## Wiltshire Council Planning Consultation Response

**Application No:** PL/2026/00347

**Proposal:** Approval of Reserved Matters (Appearance, Landscaping, Layout and Scale) Following Outline Planning Permission PL/2022/02452 for 140 Dwellings, a Habitat Support Area and Associated Landscaping and

**Site Address:** WorksLand at Stones Farm, West Mill Lane, Cricklade

Planning Layout (sheet 1 of 2) 247-06-01:

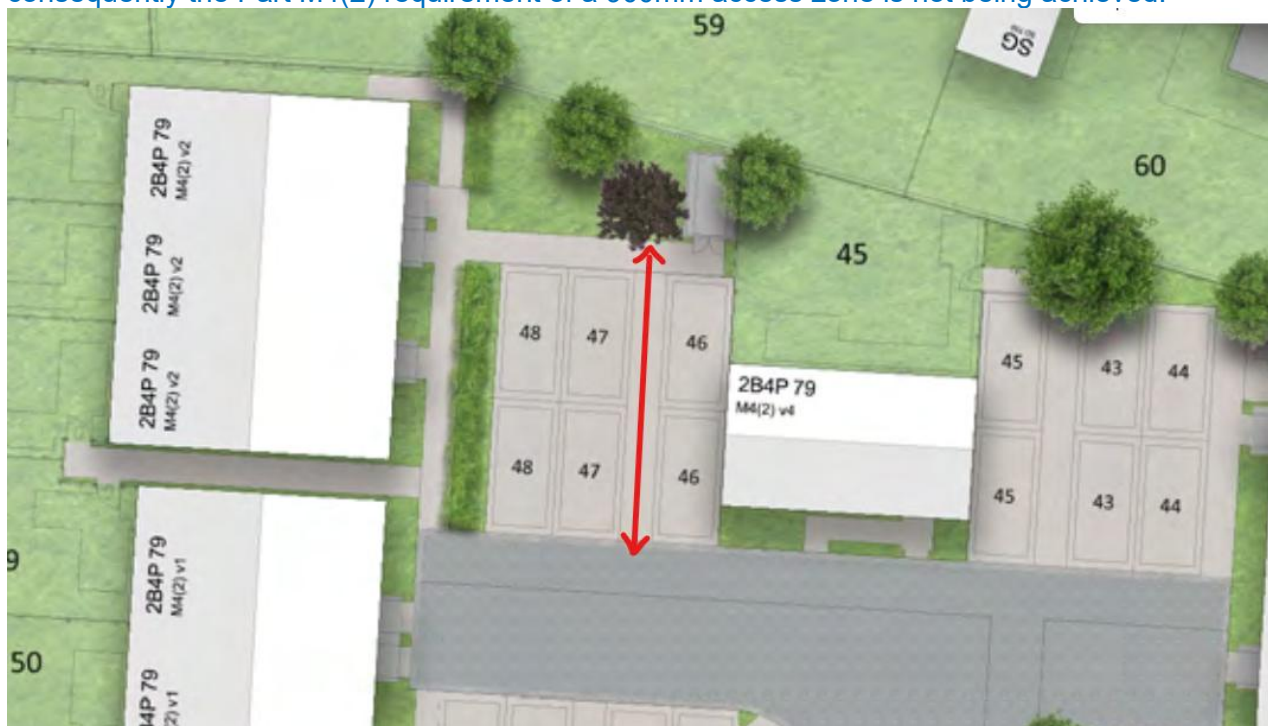
Plot 45 and plots 87 to 91 inclusive as 2 storey houses with north facing rear gardens would not adhere to WDG expectation 9.2.2 that for a typical 2 storey house this should be a minimum of 12m long.

✗ Plot 45 has marginally increased in size but the garden is still the same depth. One possible solution could amending the house design or orientation to allow light into the garden.

✗ For plots 87-91 It is acknowledged the gardens can't easily increase in depth without losing the plot to the north in most circumstances. Consideration should be given to other means of improving garden's potential for receiving sunlight. Possible solutions could include lowering roof pitches or introducing hipped roofs to facilitate more light for these north facing gardens.
